MERCUISER SERVICE BULLETIN

Number : 71-9-06

MerCruiser "888" Power Trim Pump Wiring (New Model)

Figure 1. MerCruiser "888" Power Trim Pump Wiring

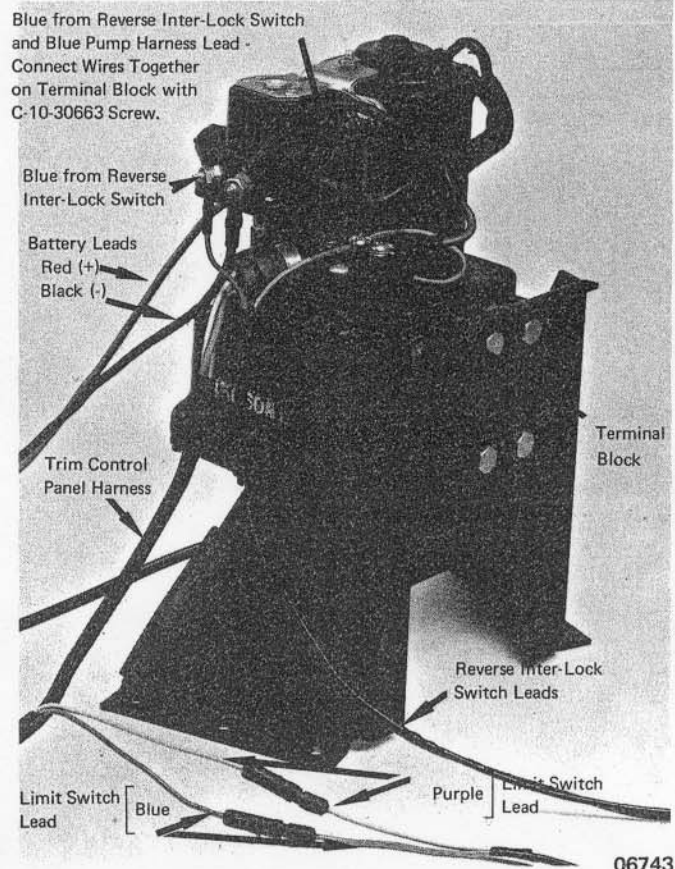
The Power Trim pumps, shipped with MerCruiser "888" Power Packages from our Fond du Lac warehouse before April 26, 1971, are wired incorrectly. The blue pump harness lead on these pumps is connected to, and must be removed from, the pump solenoid.

Inspect all MerCruiser "888" Power Trim pumps, installed in boats that you have in stock and have sold, to be sure they are wired correctly, as follows: (Refer to Figure 1 on right.)

The blue pump harness lead and one of the blue reverse interlock switch leads must be connected to the terminal block as shown in the illustration (right).

Screw C-10-30663 is required for making this connection. Order a quantity of screws to cover your units.

IMPORTANT: Correct length screw must be used to make this connection. If screw is too long and protrudes thru terminal block, wires will be shorted to ground.
